**RE: UM 1910 – PacifiCorp’s Resource Value of Solar – ERRATA FILING**

PacifiCorp d/b/a Pacific Power encloses for filing the corrected testimony of Daniel J. MacNeil (PAC/100). For convenience, both a red-line and clean version of the complete testimony are enclosed.

PacifiCorp filed opening testimony supporting its resource value of solar calculation on November 30, 2017, in compliance with Public Utility Commission of Oregon Order No. 17-357. An error was discovered in the calculation. The correction of this error necessitates the following changes to the testimony filed as PAC/100:

**Figure 5: Standard and PDDRR Avoided Costs for the Indicative Fixed Solar Resource**

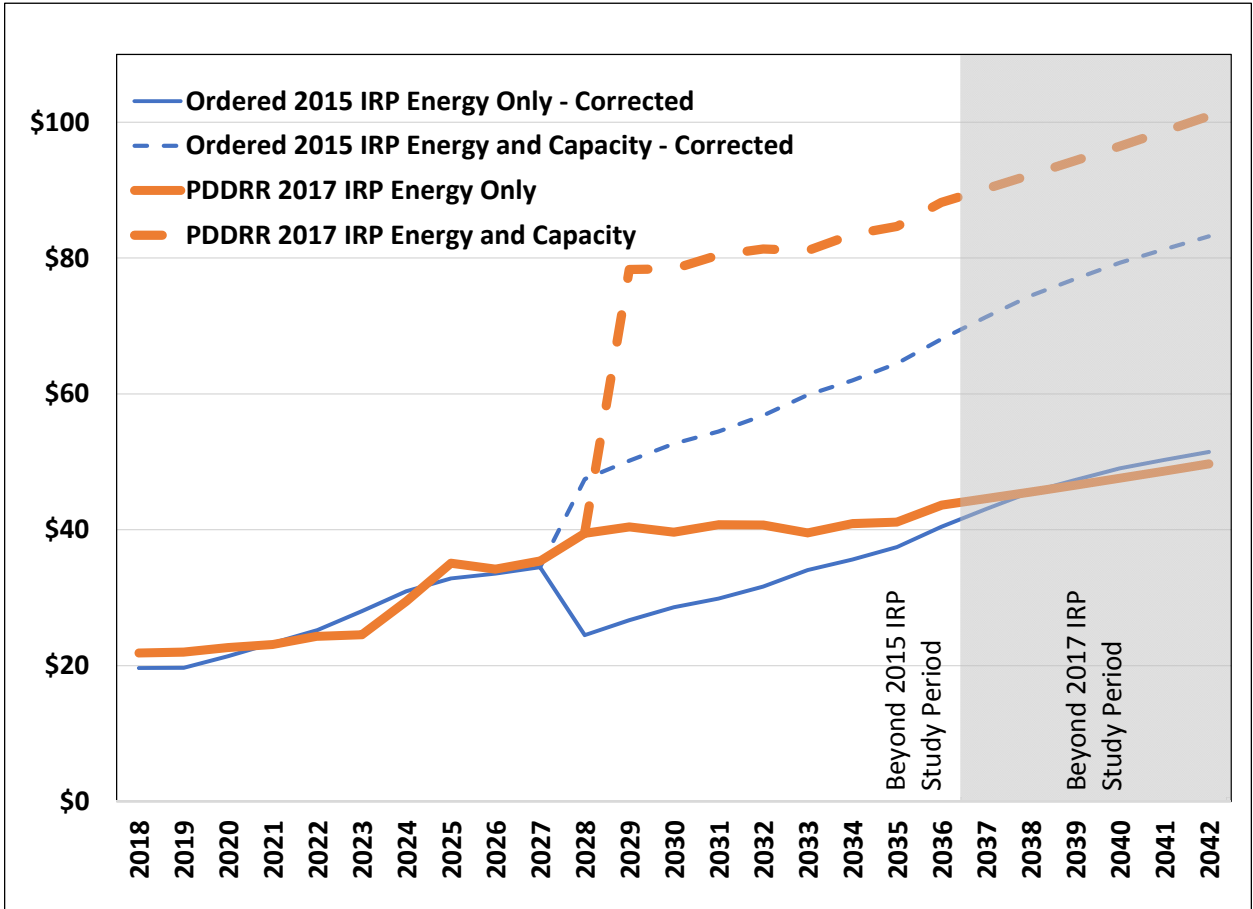
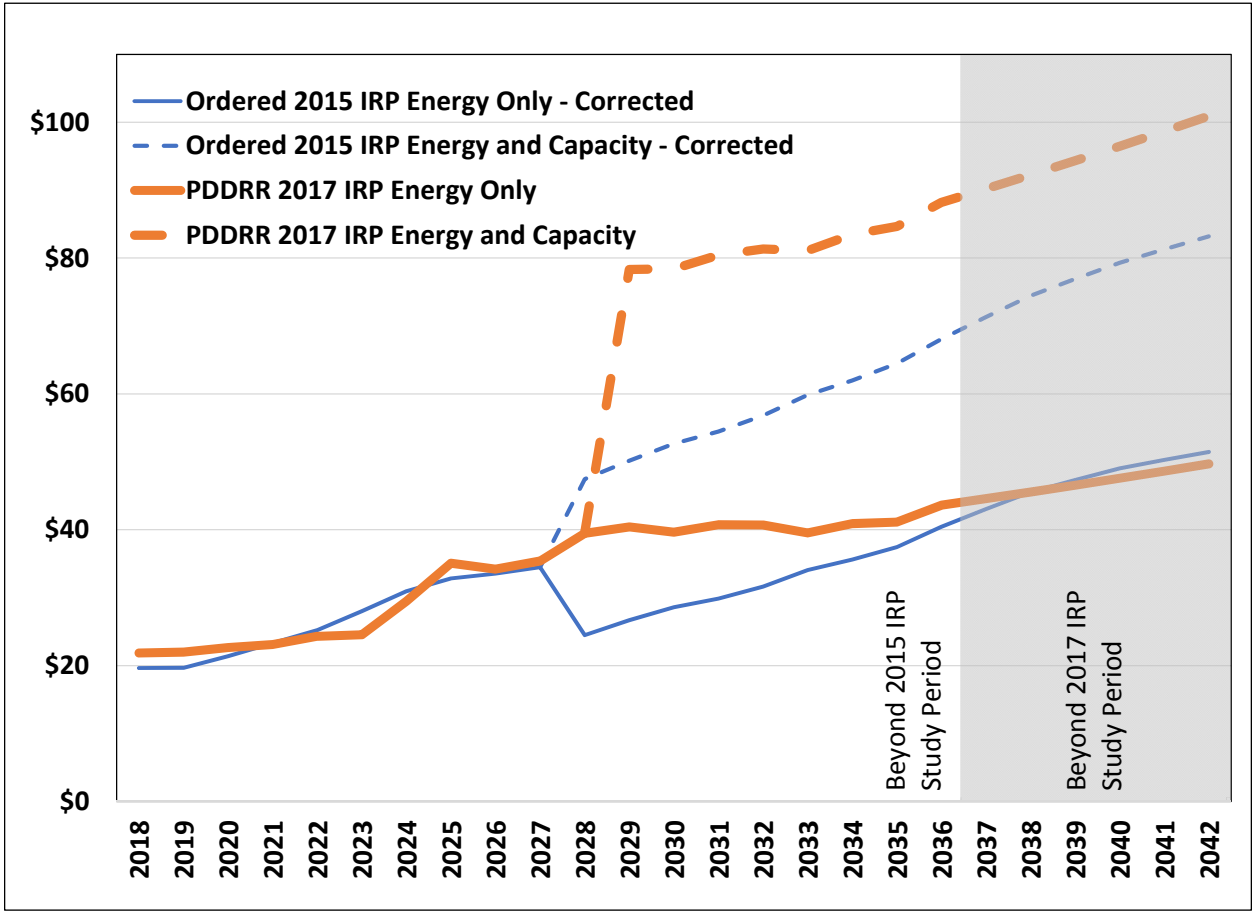
- Page MacNeil/3 – corrected Table 1 – Standard 2015 IRP column
- Page MacNeil/18 – corrected Figure 4
- Page MacNeil/35 – line 13
- Page MacNeil/46 – line 22 through MacNeil/47 – line 10
- Page MacNeil/48 – corrected Figure 5
- Page MacNeil/49 – line 4
- Page MacNeil/49 – corrected Figure 6

18 A. Annual avoided energy and capacity cost for both methodologies are shown in  
19 Figure 5. Avoided energy and capacity results under the PDDRR methodology are  
20 comparable to those under the standard avoided cost methodology during the  
21 sufficiency period. During the deficiency period, avoided energy and capacity values  
22 are lower under the standard avoided cost methodology. In part this is because the

18 A. Annual avoided energy and capacity cost for both methodologies are shown in  
19 Figure 5. Avoided energy and capacity results under the PDDRR methodology are  
20 comparable to those under the standard avoided cost methodology during the  
21 sufficiency period. During the deficiency period, avoided energy and capacity values  
22 are lower under the standard avoided cost methodology. ~~While~~ In part this is
